MAPLE STREET DEDICATION PLAT

9:21149-D
APPROVED
LORAIN CO.
MAP DEPT
DATE 12-5-94
PAGE 18-00-021-A
BY CAROLYN FRANCIS
21149-D

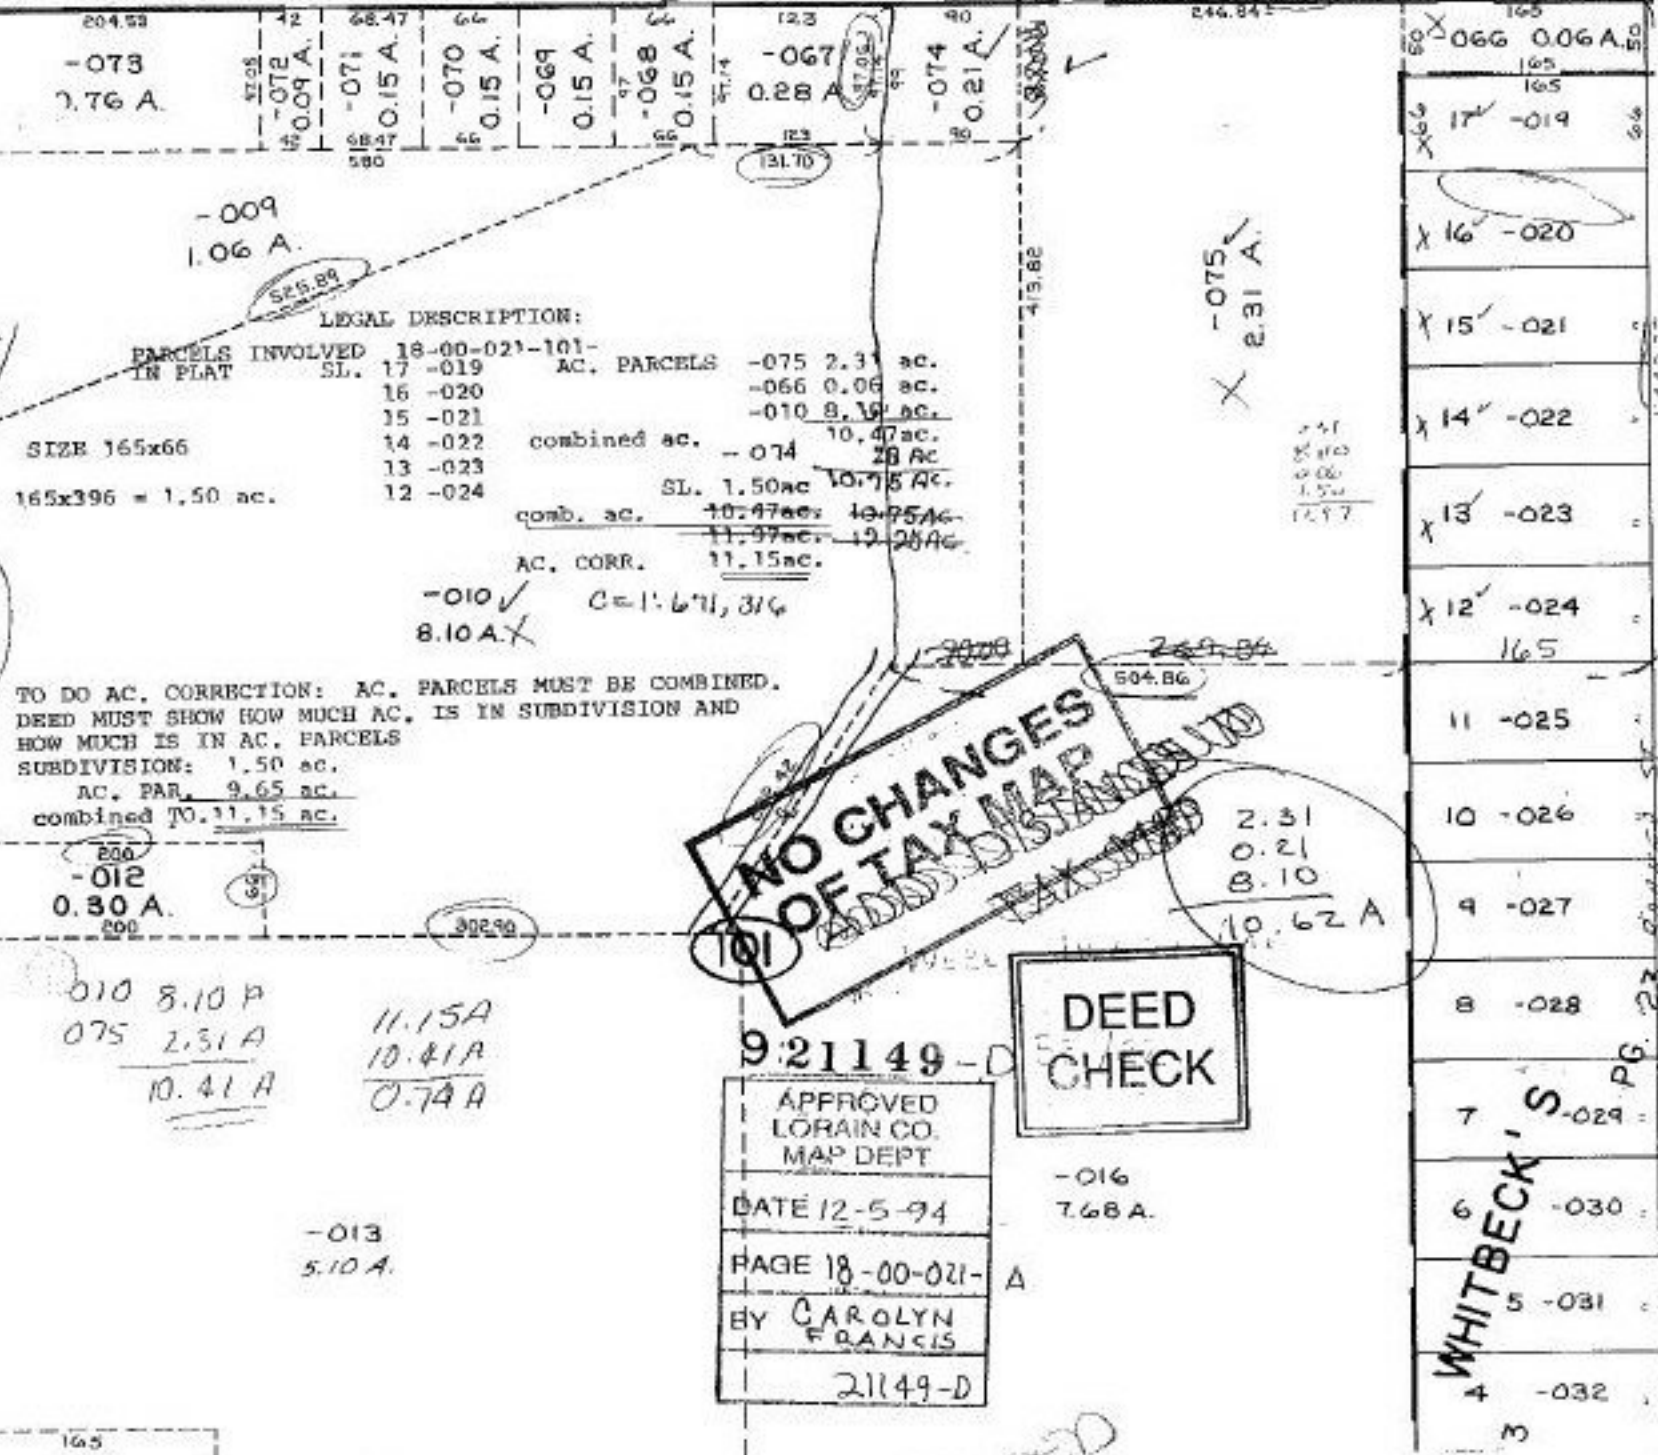
TO DO AC. CORRECTION: AC. PARCELS MUST BE COMBINED.
DEED MUST SHOW HOW MUCH AC. IS IN SUBDIVISION AND
HOW MUCH IS IN AC. PARCELS
SUBDIVISION: 1.50 ac.
AC. PAR. 9.65 ac.
combined TO 11.15 ac.

NO CHANGES OF TAX MAP
ADDITIONAL TAXES
